AGENDA
PLANNING AND ZONING COMMISSION MEETING
CITY OF CREVE COEUR, MISSOURI
MONDAY, MARCH 3, 2014
7:00 PM

A. Application #14-004: Rezoning of 853 N. Mason from A Single-Family Residential to D Single Family Residential District with RDD Designation

ON APPLICATION TO PLANNING AND ZONING COMMISSION #14-004
FOR REZONING TO "D" SINGLE FAMILY RESIDENTIAL AND APPROVAL OF A
PRELIMINARY PLAT ACCORDING TO THE RESIDENTIAL DESIGN DEVELOPMENT
(RDD) PROCEDURE FOR THE CREEKSIDE AT MASON SUBDIVISION
FOR THE MEETING OF: Monday, March 3, 2014

Tree Census

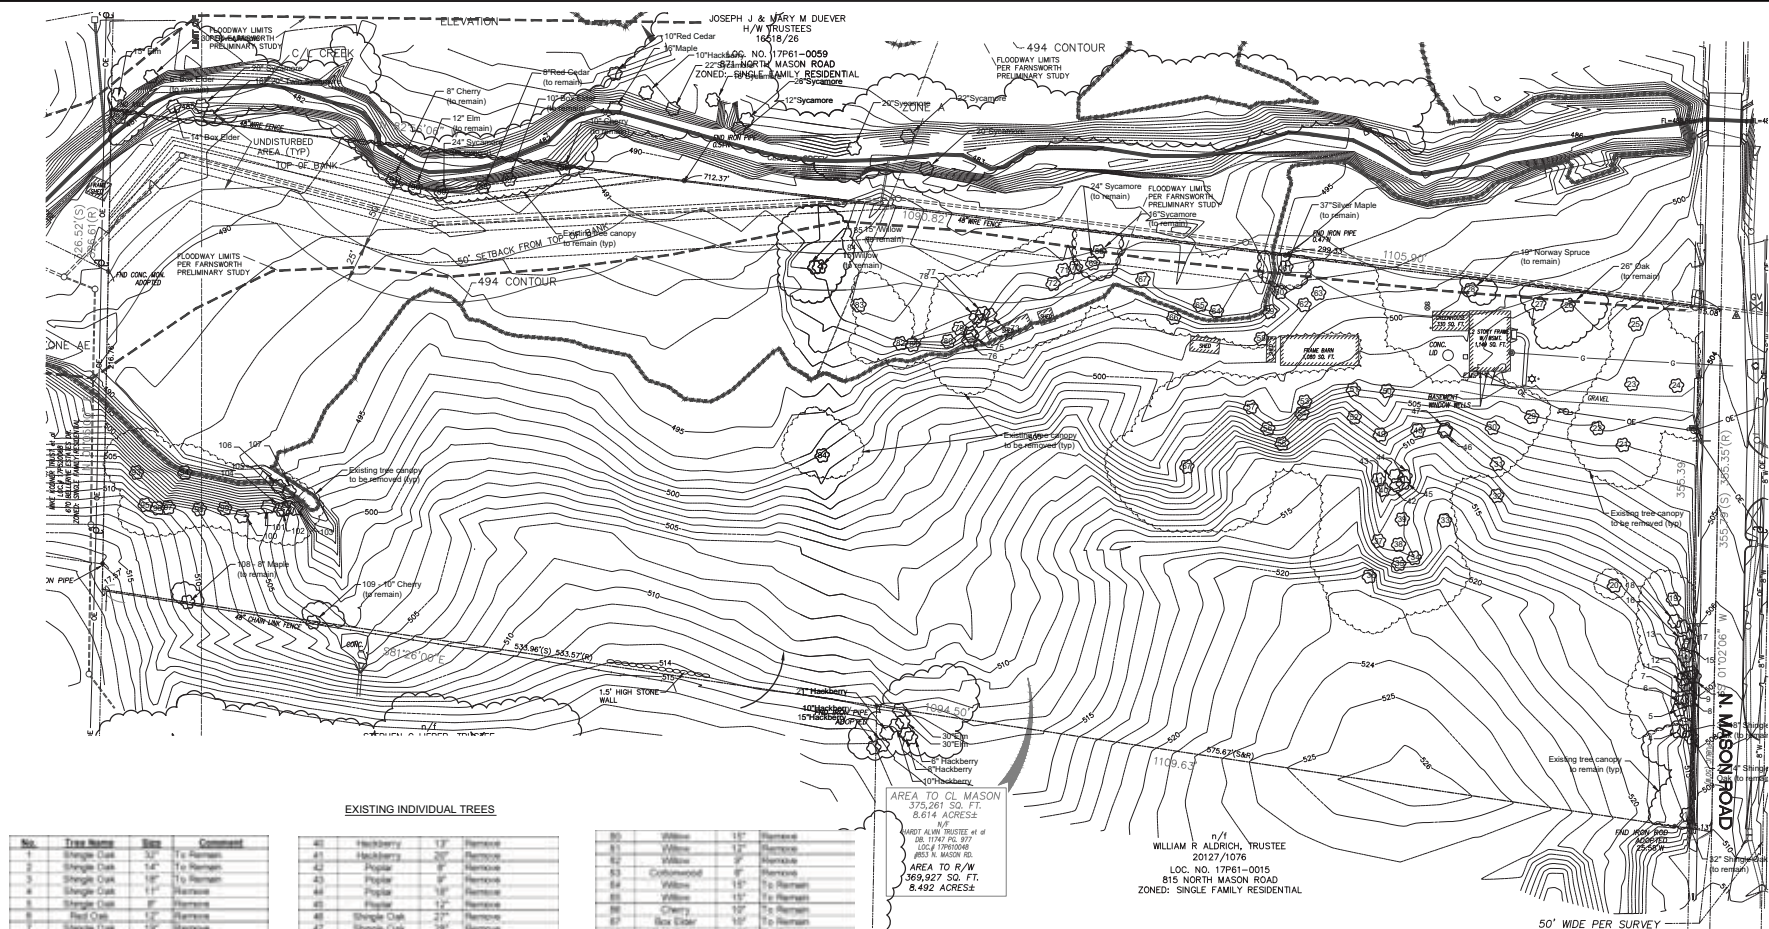
The Tree Preservation Plan submitted indicates that the property has approximately 1.9 acres of tree canopy and, if approved, 85.3% of this mass will be eliminated. As discussed above, the minimum standard is that 25% of the trees must be preserved, as required by the section below. Therefore Staff has included a condition that the Landscape Plan shall be revised to meet with Section 410.320 of the Subdivision and Land Development Standards

- The grading plan shall be revised to reduce the impact on existing tree masses to the extent that a minimum of 25% of the existing tree mass shall be preserved, subject to Zoning Administrator approval.

6. The grading plan shall be revised to reduce the impact on existing tree masses to the extent that a minimum of 25% of the existing tree mass shall be preserved, subject to Zoning Administrator approval.
